REVISED

REF: SUP25-0010
DATE: April 10, 2025

Request	-	Special Use Permit for stand-alone solar array
Location	-	0 Dura Avenue
Applicant / Developer	-	Project Beacon, LLC 5100 W. Central Avenue Toledo, OH 43615
Engineer	-	Verdantas 219 S. Erie Street Toledo, OH 43604

SITE PLAN 2

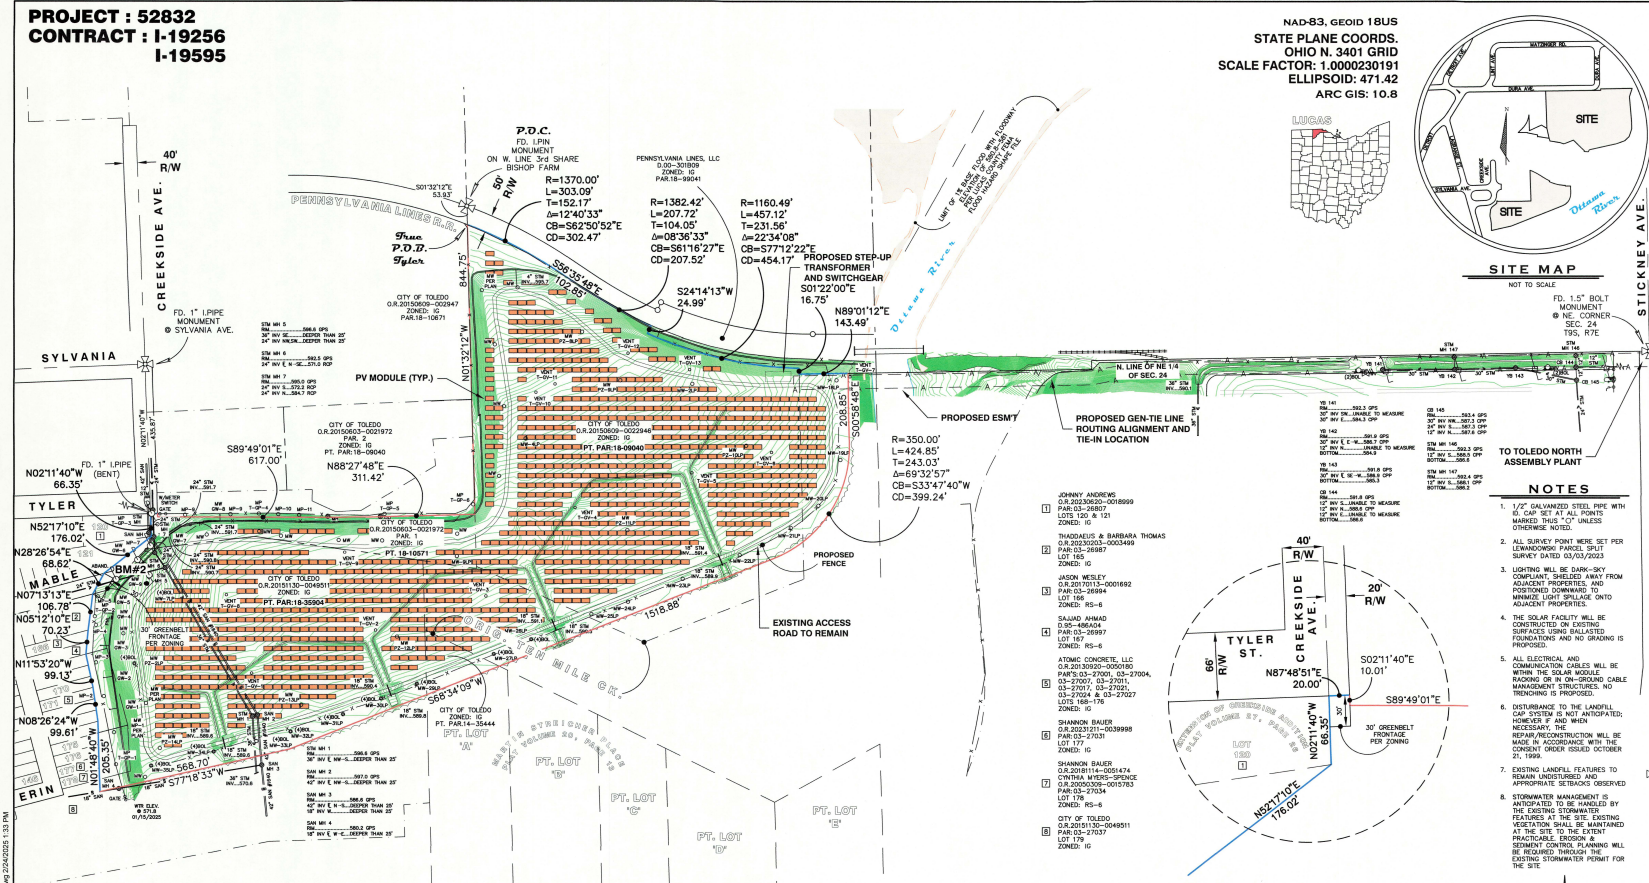
5. A SWP3 submittal is required; note 8 on each sheet of the proposed site plan is insufficient to meet the requirement, since a 513 permit for one of the landfills is the only document that calls out surface water management, and the requirements of the 513 are not known to be to the standards of the Ohio Construction General Permit. Toledo requires a SWP3 for projects over 2,500 square feet of construction activity. Placement of the fill (ballast) would constitute a construction activity. The total disturbance of the project would not just be the footprint of the ballasts however and would also include the remainder of the area that will be disturbed by construction activities, including construction traffic. If any of the site is to experience heavy construction traffic from equipment and will disturb the earth, that would need to be accounted for in the calculation of the total disturbed area. The entire project including the electrical transmission work offsite will need tallied, and if greater than an acre, an NOI will also be need to be submitted and authorized by OEPA.

7. Provide 60 ft wide clear space above the 36" storm and 42" sanitary sewers.
